Appendix E – Earthworks Plans (Northrop)

Fairmont Port Douglas – RFI Response

DA Reference : MCUI 2020_3711/1

Item 8 :

200372-DA-C03.01

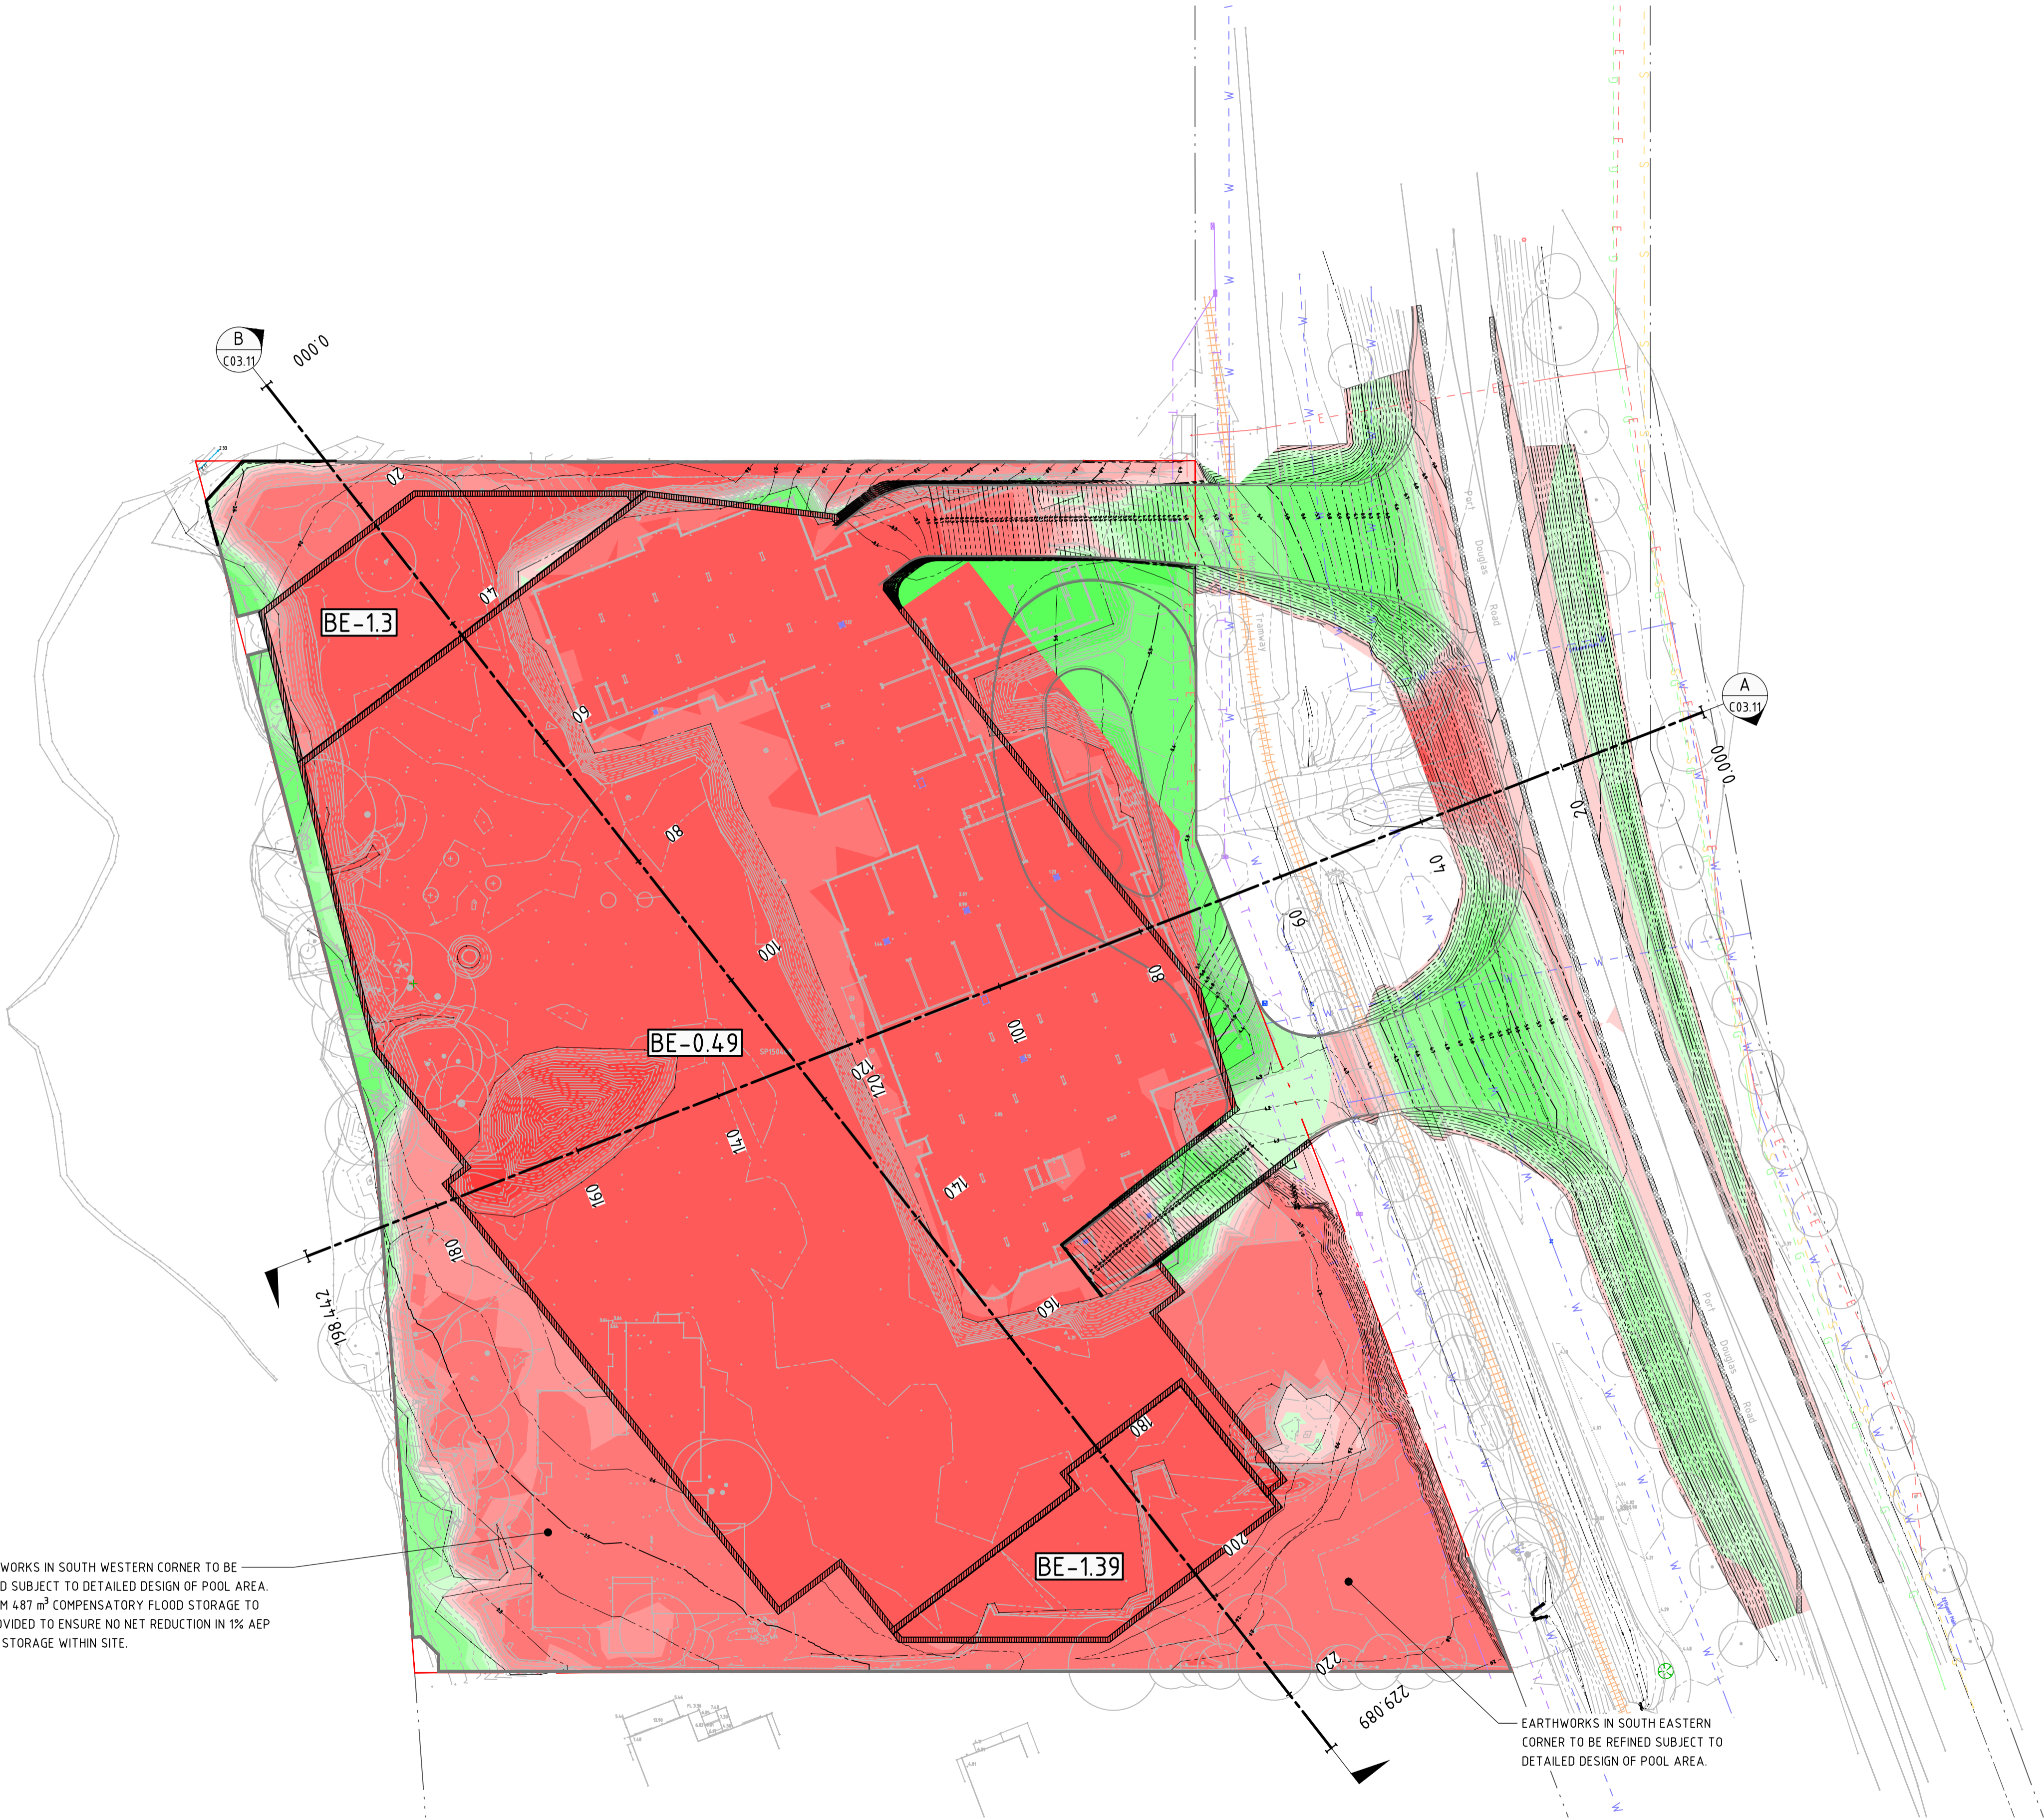
The location of Section A on Northrop Drawing 200372-DA-C03.01 does not pick up the filling along the western boundary where the existing drainage swale meanders in and out of the property. The low areas are evidenced by the green shading in the Northrop drawing. Concern is raised with the south west corner, (but not limited to this location), where the swale appears to be largely within the subject site. Council Officers are concerned that the proposed filling may impede the drainage line and displace the runoff and drainage to third parties, in conflict with the planning scheme, FNQROC Development Manual and QUDM.

Filling adjacent or within the water body near the north west boundary must also be considered and further detail must be provided on how this will be achieved without impacting on the adjoining landowner.

The location of Section A has been changed to better illustrate the filling along the western boundary. Note that as some filling of the lagoon edge within the site is proposed this will require compensatory flood storage to be provided within the site as noted on the drawings to be detailed/provided at the detailed design stage in the southwestern corner.

The extent of earthworks has been pulled back in the north-western corner to leave the existing overland flow path through the corner of the site uninhibited.

EARTHWORKS IN SOUTH WESTERN CORNER TO BE REFINED SUBJECT TO DETAILED DESIGN OF POOL AREA. MINIMUM 487 m³ COMPENSATORY FLOOD STORAGE TO BE PROVIDED TO ENSURE NO NET REDUCTION IN 1% AEP FLOOD STORAGE WITHIN SITE.
